Knit Plus Ltd (Extension - 2)

7 June 2026

1. 10 Storied Green Building: Ten-storied (B+G+9) RC building with a basement

2. Observations

COLUMN LAYOUT PLAN (1ST FLOOR TO ABOVE)

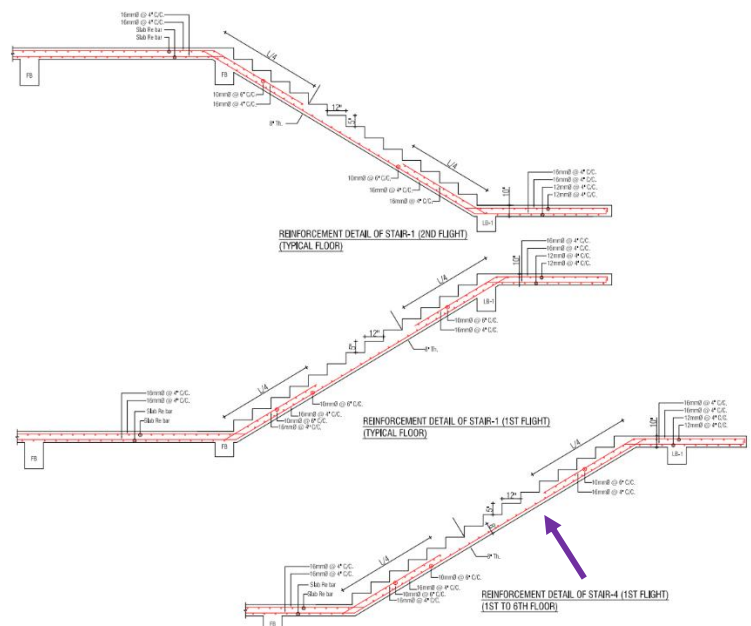
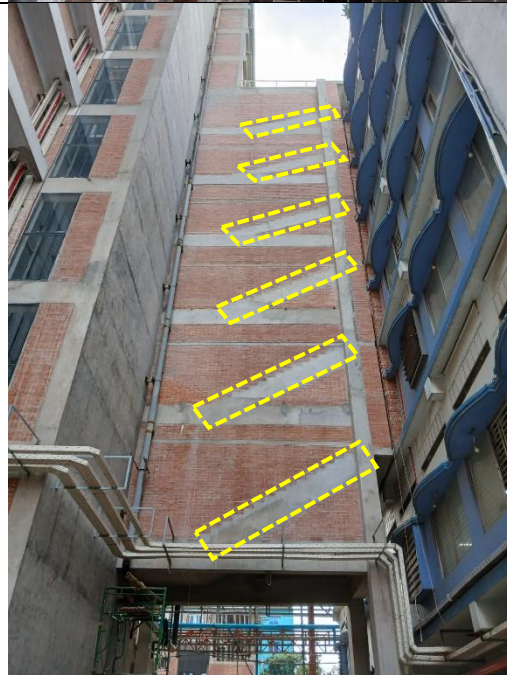
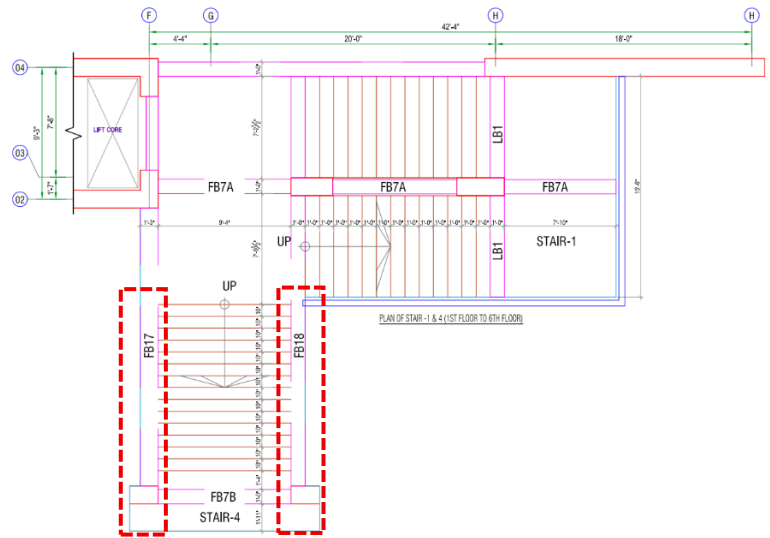
Observation-01: Stress in the columns exceeds the normal design limit considering minimum concrete strength (10 Storied Green Building)

Description: Cursory calculation indicates that the marked columns are marginally overstressed considering minimum concrete strength 16.3 MPa (based on aggregate type) and prepared live load plan [4 kPa in typical floor and 6 kPa in storage area].

In the prepared design report, 5000 psi design strength was considered for columns, shear walls, and foundations, and 4000 psi for beams and slabs. During the inspection, 49 sets of cylinder test reports [Foundation = 4; Columns and Shear Walls = 26; Beams and Slabs = 19] were available, which do not meet the testing frequency requirements of BNBC 2020 (Section 5.12.2).

The building engineer is required to verify the in-situ concrete strength of each type of structural member by taking 100 mm diameter cores (minimum 4 nos.) from lower-tier columns and floor members (beams and slabs).

The building engineer is also required to check the column stress based on in-situ concrete strength, revise the design report and submit the revised design documents to RSC for detailed review against lateral forces.
